Model(s)	Year(s)	VIN Range	Vehicle Specific Equipment
e-tron GT, and RS e-tron GT	2022 - 2024	All	Not applicable

REVISION HISTORY		
Revision	Date	Purpose
3	-	Revised <i>Service</i> (Updated repair information) Revised <i>Warranty</i> (Updated Labor operations)
2	02/12/2026	Revised <i>Condition</i> (Added model table) Revised <i>Service</i> (Added campaign handling information)
1	05/05/2025	Initial publication

The previous high-voltage battery assembly for the e-tron GT with the part number **9J1.915.100.*** is no longer available for delivery. For this reason, part number **9J1.915.590.*** must be used if a replacement battery is required. A small number of attachments must be replaced (Figure 1) and several steps listed under Measure must be observed.

Figure 2. Label position location.

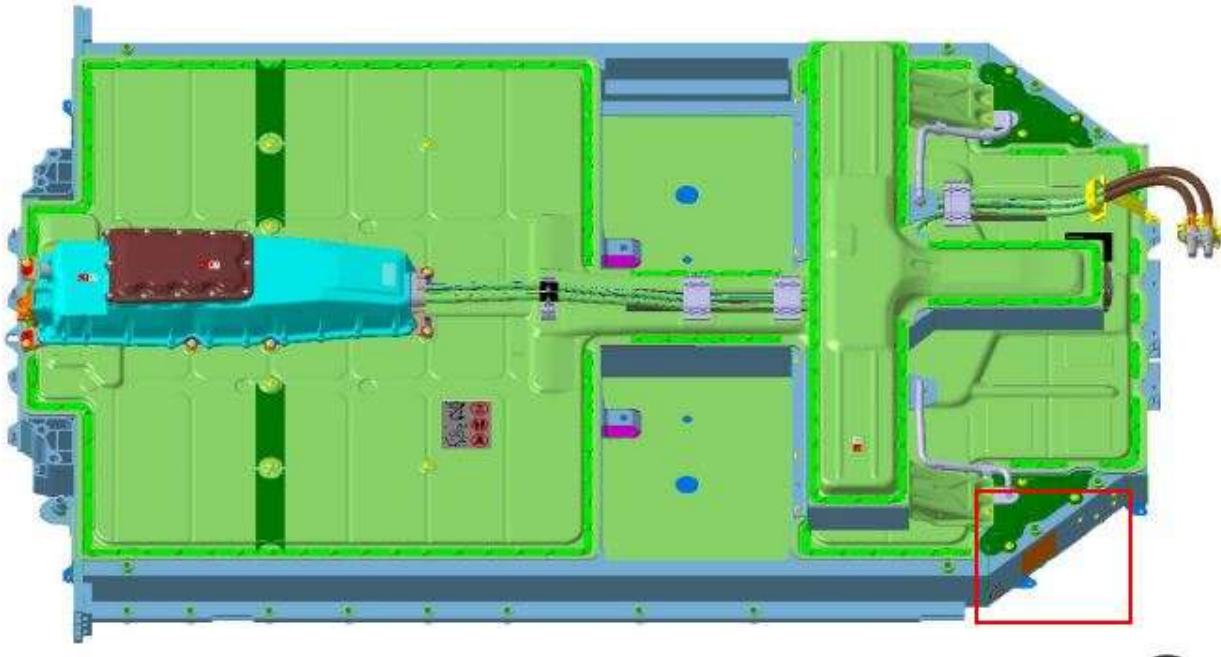
- Fit attachments for front coolant connection (b): **9J1.122.293.J** and **9J1.122.293.K**
- Affix notice **9J1.01.003.B** (E test mark) next to high-voltage battery type plate (Figure 2).
- Print KBA-92109 label using a label printer and affix it next to the high-voltage battery type plate.

The KBA-92109 label is currently being created and will soon be available with a part number. Until then, please use a label printer/labelling machine in the workshop. A label with the text “KBA-92109” but be applied on the high-voltage battery next to the type plate.

Figure 3. Stabilizer link.

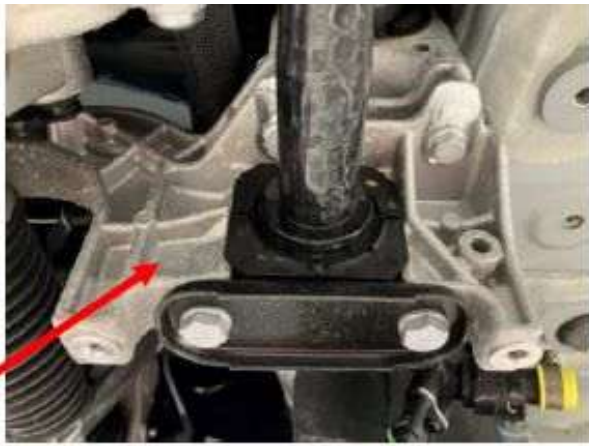
- Replace stabilizer links (both sides) to the geometry of the e-tron GT PU

- Replace stabilizer link (left side) **9J1.413.357.A** with **9J1.413.357.B**
- Replace stabilizer link (right side) **9J1.413.358.A** with **9J1.413.358.B**
- Replace bolts (stretch bolts) and check rubber bushes for wear; replace if necessary

Figure 5. Bracket.

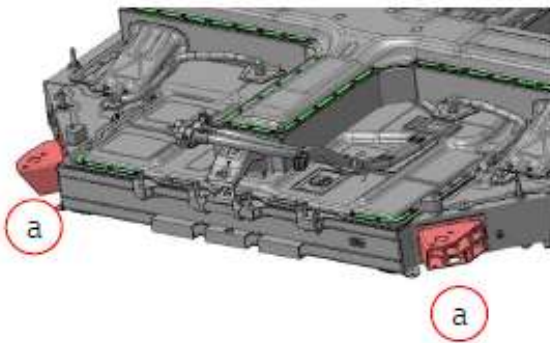
Fitting rear brackets 9J1.804.695/.696 (a) to high-voltage battery and torque to specification.
